Subject: Docket 50-482: Wolf Creek Nuclear Operating Corporation's  
Response to Request for Additional Information Regarding 10 CFR  
50.55a Requests I2R-37 and I2R-38

**Response to Request for Additional Information (RAI) Regarding 10 CFR 50.55a (Relief)  
Requests I2R-37 and I2R-38**

**Figure 1**

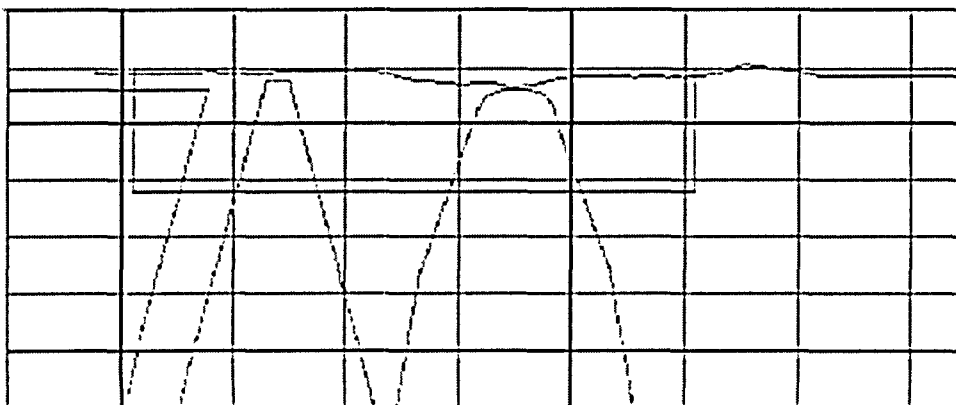
- (2) Describe the extent and locations of the observed surface irregularities and provide explanation with the assistance of sketches to show that the observed surface irregularities will only affect the detection of axial flaws. Also, discuss what measures you have taken to ensure that the surface condition of the weldment will provide a reliable eddy current examination.

The surface irregularities are located around the inside diameter of the subject welds and are the result of counterbore tapers and/or grinding of the root pass. These surface irregularities do not meet the criteria for smoothness as stated on the Performance Demonstration Qualification Summary (PDQS) for the procedure.

Examination of these welds was performed using a qualified and demonstrated procedure, PDI-ISI-254-SE. During the qualification of this procedure, the detection of axial flaws was limited due to severe irregularities in the inside diameter (ID) contact surfaces of the Performance Demonstration Initiative (PDI) test set. The detection of circumferential flaws met the Appendix VIII criteria on these surfaces with severe irregularities during the PDI performance demonstration. The attached figures 1 and 2 illustrate examples of mapped ID surface irregularities that limited the detection of axial flaws during the qualification of the vendor's procedure, but did not limit the detection of circumferential flaws.

**Figure 3**  
**Inlet piping to safe-end and safe-end to inlet nozzle welds**

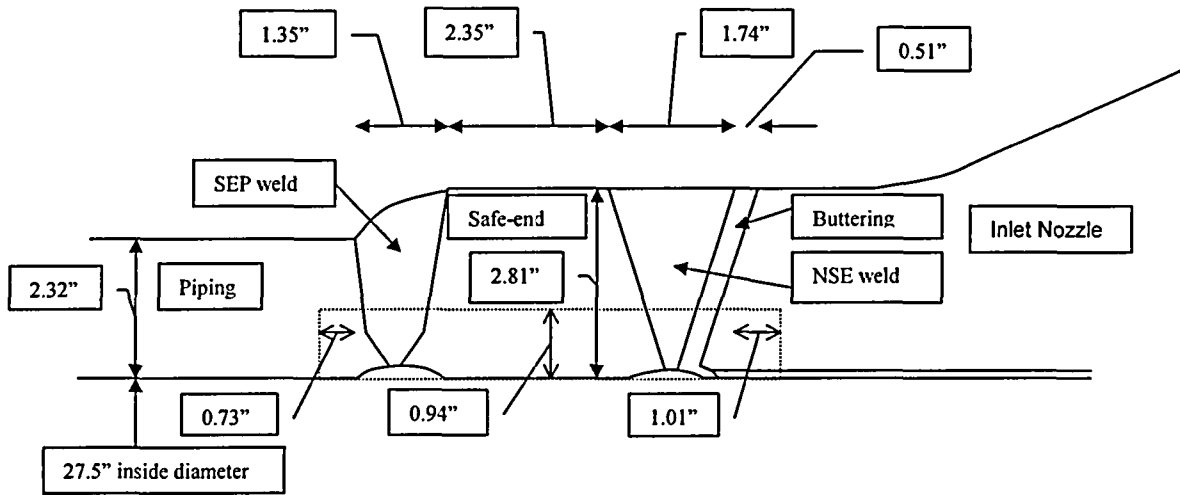
(3) For each listed safe-end component, provide the information with a sketch regarding the dimensions of the components and welds, materials, component names and the dimensions of the code required inspection volume.

See attached Figures 3 and 4 for dimensions and the table below for the component and weld material.

Per Figure IWB-2500-8(c) of ASME Section XI, the volume required to be examined is the inside surface extending up to 1/3 of the thickness of the piping and extending out to 1/4" past the edge of the weld crown on each side of the weld. The volume that was actually examined is shown by the dotted line box in the Figures 3 and 4. The figures show that the examined volume extends well beyond that required by the Code. This additional volume was added by the vendor as a "conservative scan factor".

Nozzle to Safe-end (NSE) welds	Safe-end to Pipe (SEP) welds
RV-302-121-A	BB-01-F102
RV-302-121-B	BB-01-F202
RV-302-121-C	BB-01-F302
RV-302-121-D	BB-01-F402

BB-02-FW301; 6" 180 degree return (SA-312 TP304) to 6" flange (SA-312 TP304) with weld filler material of 308.

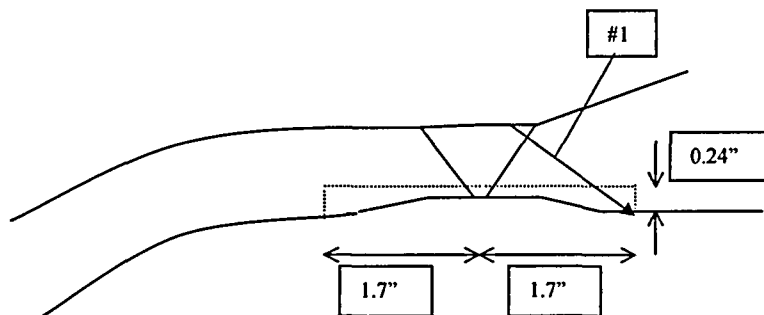
- (2) Provide the following information for each listed piping weld with the assistance of a sketch:
- materials, names and dimensions of components and welds, and
  - dimensions of the Code required area of examination coverage and the actual area of coverage based on the best effort examination.

Joint size: 6" sch. 160, nominal OD 6.625", nominal thickness 0.719"; counterbore ID 5.325"

This examination area extends to 0.25" beyond the counterbore as required. The amount of axial coverage obtained by the best effort examination, utilizing the supplemental 60 degree longitudinal wave search unit, is 85.2% of the area on the far side of the weld. Arrow #1 in the diagram above depicts the extent of the best effort examination perpendicular to the weld. The best effort parallel scan was conducted to the extent possible from the weld crown. This scan examined 32.4% of the area on the far side of this weld.
